Access Compliance Report

Public Rights-of-Way

Intersection ID: 29303	Main Street: OAKDALE_GREEN_DR	Cross Street: WHISPERING_BROOK_CT	Location: NW
ADA ID: F1987206DCC3	Ramp Type: Perp	Initial Pass/Fail: Fail	Overall Compliance: No
Severity Score: 45			
Codes/Mitigation Info/Possible Solution		Field Measurements/Component Compliance

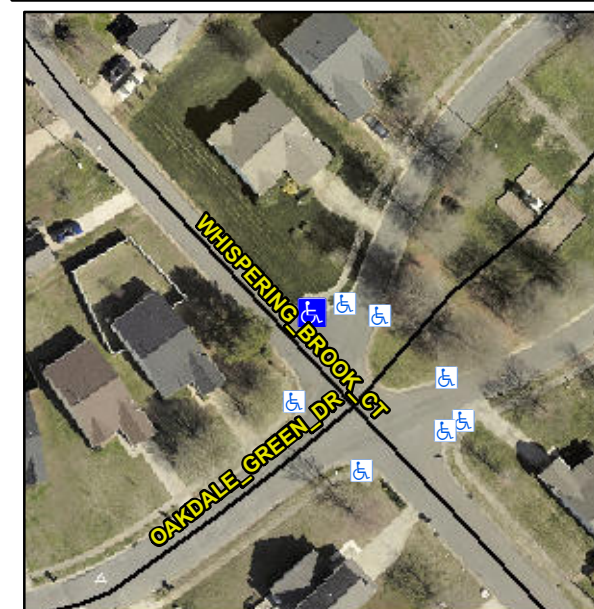
Not Found, R304.5.1, R304.5.3, R302.7

Compliance	Description	Data	Compliance	Description	Data
N/A	Ramp Length (in)	96.0	Yes	Ramp Slope (%)	8.2
No	Ramp Width (in)	34.0	No	Ramp XSlope (%)	6.5
N/A	Flare Type LT	N/A	N/A	Flare Type RT	N/A
N/A	Flare Slope LT (%)	N/A	N/A	Flare Slope RT (%)	N/A
N/A	Flare Traversable LT?	N/A	N/A	Flare Traversable RT?	N/A
N/A	Landing Length (in)	N/A	N/A	DWS Provided?	N/A
N/A	Landing Width (in)	N/A	N/A	DWS Contrast?	N/A
N/A	Landing Slope (%)	N/A	N/A	DWS Length (in)	N/A
N/A	Landing X Slope (%)	N/A	N/A	DWS Full Width?	N/A
N/A	Landing Curb? (Y/N)	N/A	N/A	DWS Offset (in)	N/A
N/A	Shared Landing?	N/A			
N/A	Gutter Ponding?	N/A	N/A	Gutter Slope (%)	N/A
N/A	Gutter Lip Ht (in)	N/A	N/A	Gutter X Slope (%)	N/A
N/A	Painted X Walk1?	No	N/A	Painted X Walk2?	N/A
	X Walk 1 Direction	To SW		X Walk 2 Direction	N/A
N/A	X Walk 1 Width (in)	N/A	N/A	X Walk 2 Width (in)	N/A
	X Walk 1 Slope (%)	0.3		X Walk 2 Slope (%)	N/A
	X Walk 1 X Slope (%)	5.2		X Walk 2 X Slope (%)	N/A

N/A	Ramp inside XWalk1?	N/A	N/A	Ramp inside XWalk2?	N/A
	Road Slope (%)	N/A	N/A	Clear Space?	N/A
	Road X Slope (%)	N/A	N/A	Clear Space to XWalk (in)	N/A
N/A	Any Obstructions?	N/A	N/A	Storm Grate/Utility Hazard?	N/A
	Obstruction Type			Storm Grate/Utility Type	
		N/A			N/A
		No		Surface Condition? (G/P)	Poor

Remove & Replace Entire Ramp.
